VILLAGE BOARD AGENDA Wednesday, July 5, 2023 at 7:00 PM

Consideration: Specific Implementation Plan, Academy of Little Vikings, 1991 Commerce Drive

To: Village of Mount Horeb Plan Commission
From: Village Planner Ben Rohr, AICP
Date: May 24, 2023
Re: Specific Implementation Plan (SIP) and Design Review for the Proposed 1-Story 1,910 sf Building Addition at 1991 Commerce Drive for Academy of Little Vikings.

ACADEMY OF LITTLE VIKINGS	MADISON, WISCONSIN	SITE LIGHTING LAYOUT
---------------------------	--------------------	----------------------

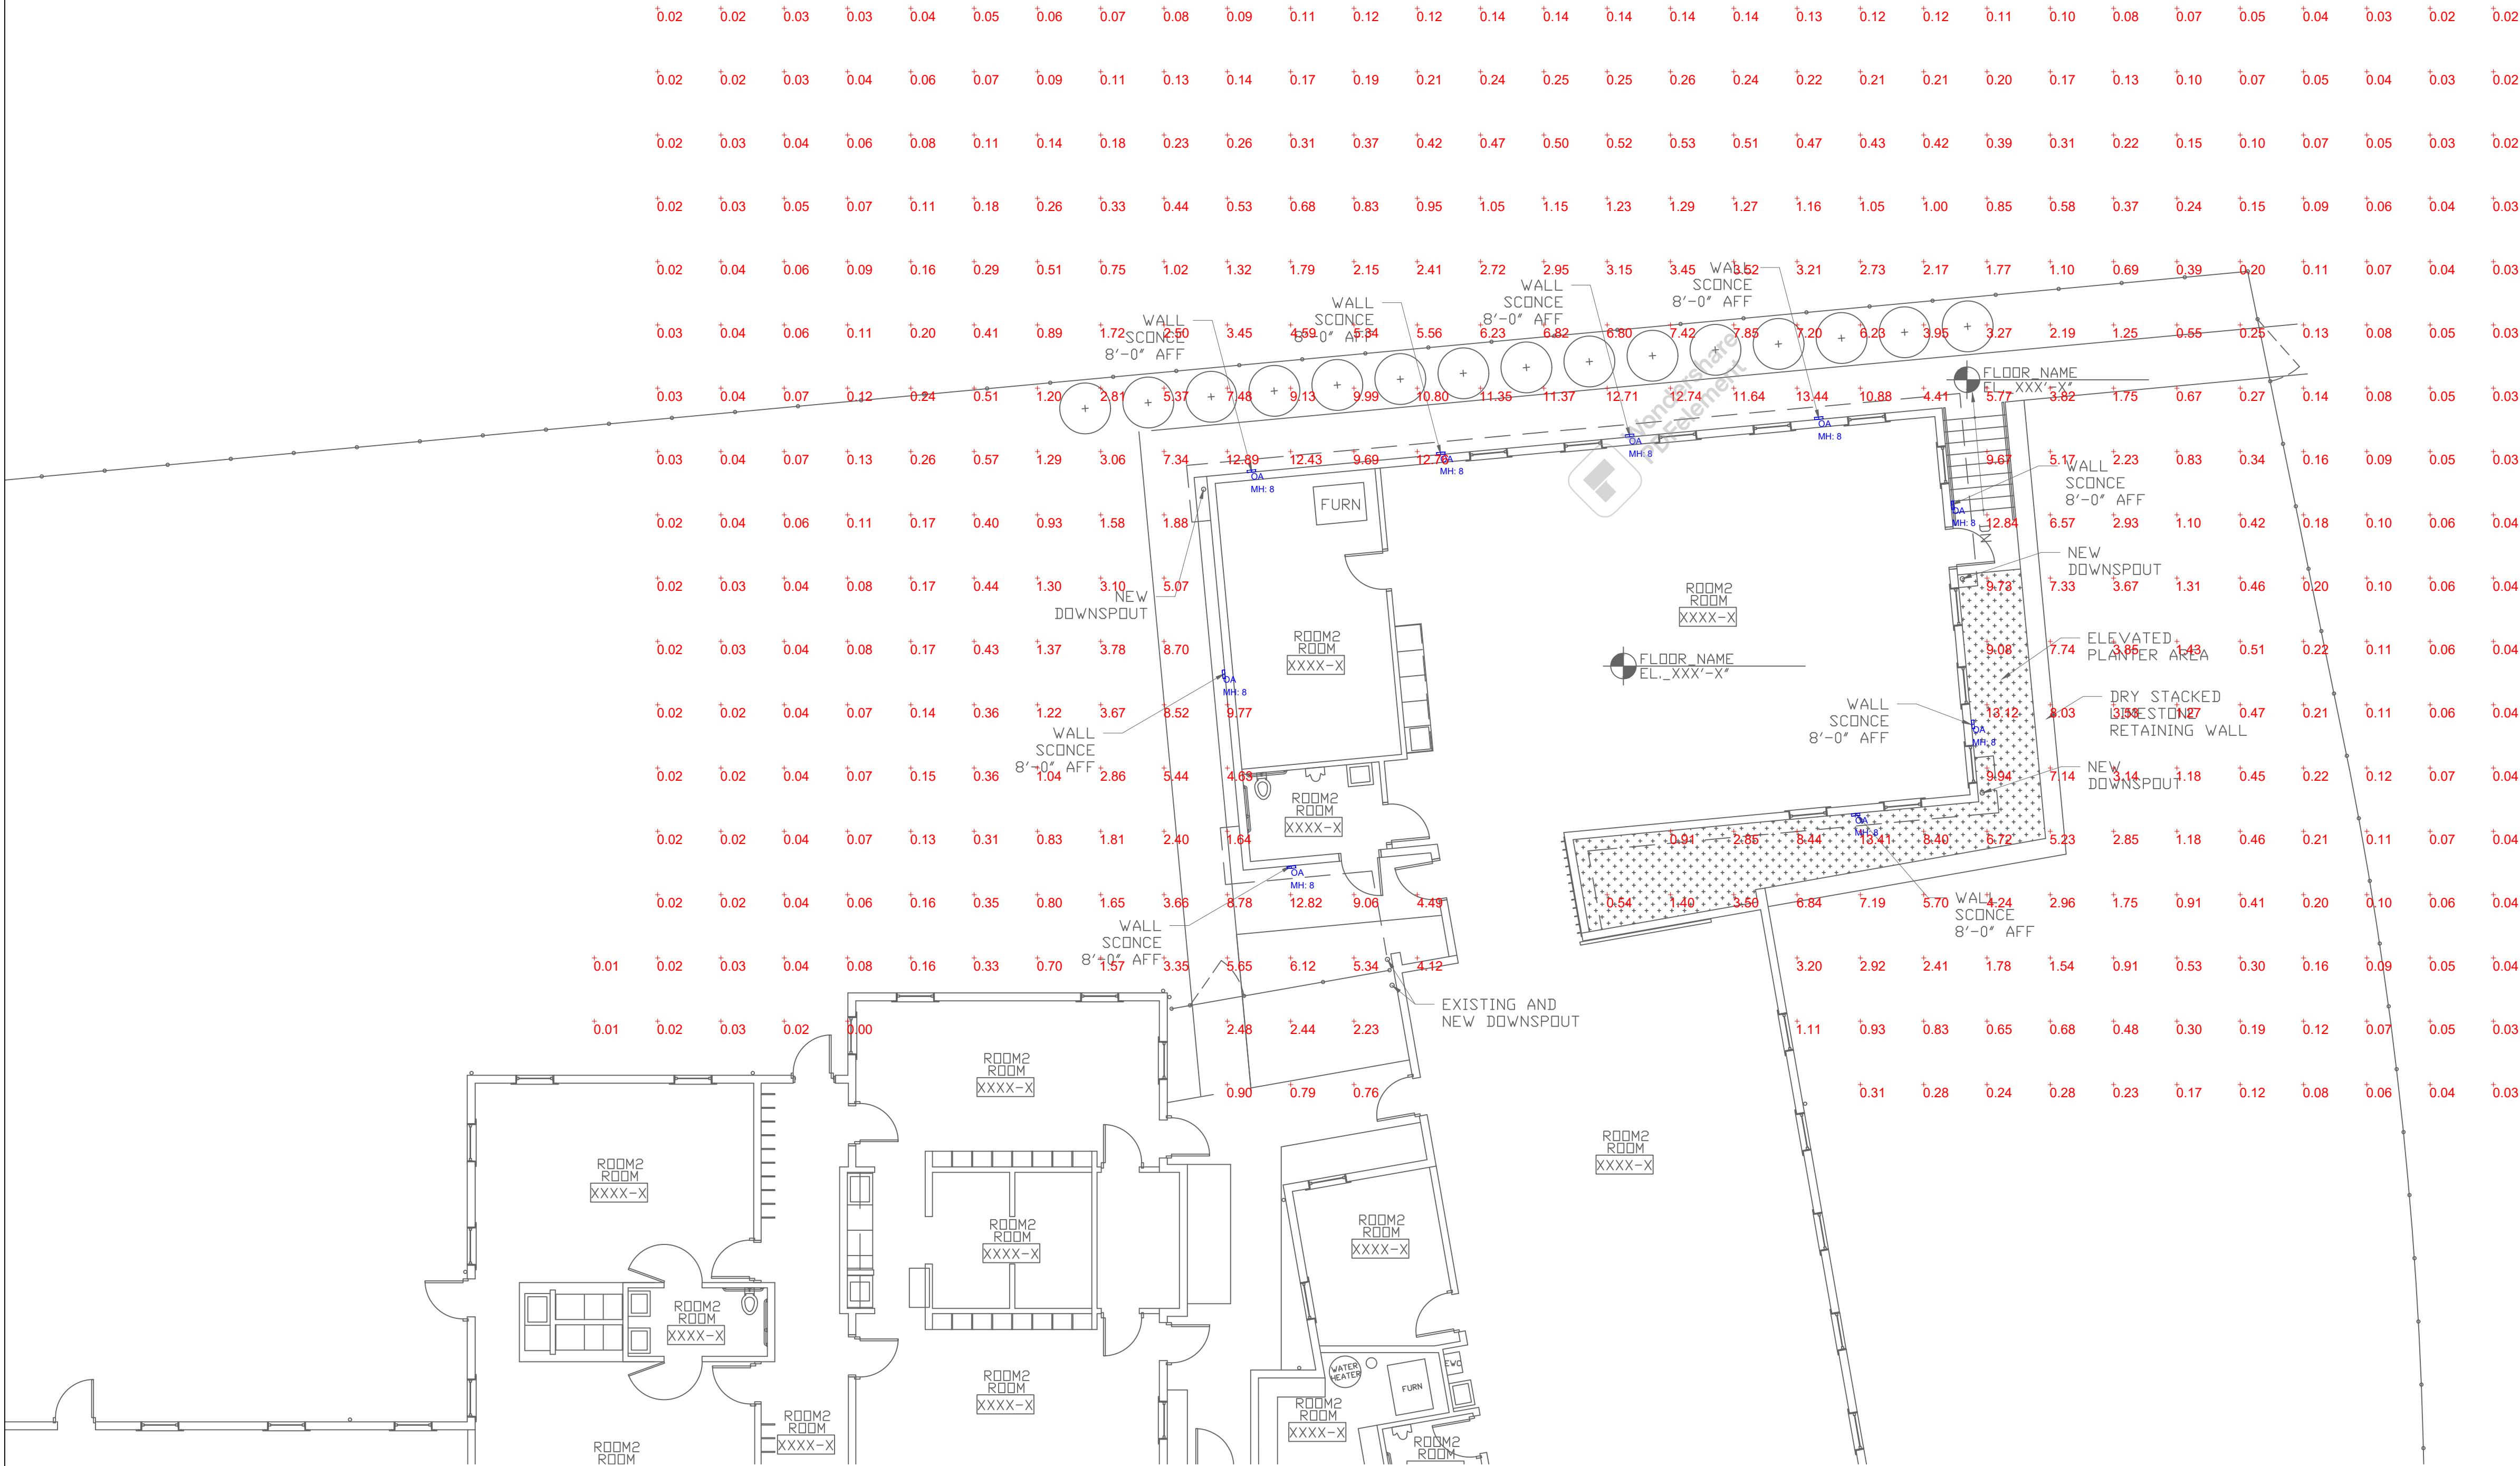
- This requirement is met.
- c. Lighting at the property lines shall not exceed 0.5 footcandles over ambient conditions.
 - This requirement is not met. The Lighting Plan shows footcandles in excess of 7.0 at the northern property line. I recommend waiving this requirement in conjunction with my comments below in d. With only 9 feet between the building addition and the northern property line, it may not be possible to meet the 0.5 footcandle standard, but the fixtures could be changed to reduce the amount of footcandles emitted from each fixture that would result in this being less of a concern.

- b. 18.c. for allowing greater than 0.5 footcandles to be emitted at the northern property line, only if the requirements of 4. below are met.
4. Require the applicant to update the Lighting Plan with different fixtures proposed on the building addition to reduce the footcandles emitted from each in compliance with the Village Zoning Ordinance (maximum of 10.0 on-site). Village staff review and approval of a revised Lighting Plan.
